SB (Service Bulletin)

2014 Dual Stage Snow Thrower with Belt Wear

Date of Bulletin: 2015-02

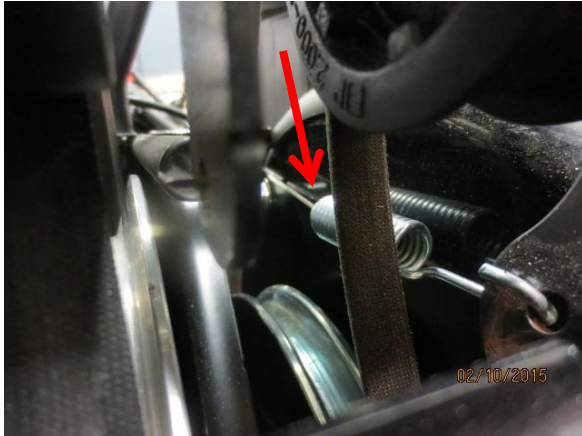
4. Remove the belt and check the surface of the pulley's v-groove. If the v-groove surface is rough to the touch or if there are grooves, polish the engine pulley by carefully touching a steel wool grade 00 pad (such as a Scotch-Brite Ultra Fine pad) to the surface of the pulley's v-groove while the engine is running. Install new belt.

Before polishing – rough surface near top of pulley

After – shiny and smooth v-groove surface

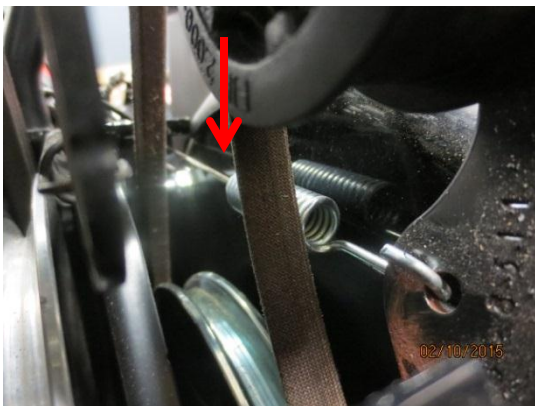
5. Check the auger cable. If the unit engages without pressing levers, the auger cable is too tight. Adjust the auger cable out to decrease tension.

(Correct) Note the slight sag in the auger cable and spring. There should be very slight sag to prevent the return spring from stretching.

(Correct) The return spring should be fully retracted as shown. If this spring is extended, this can begin to release the impeller brake.
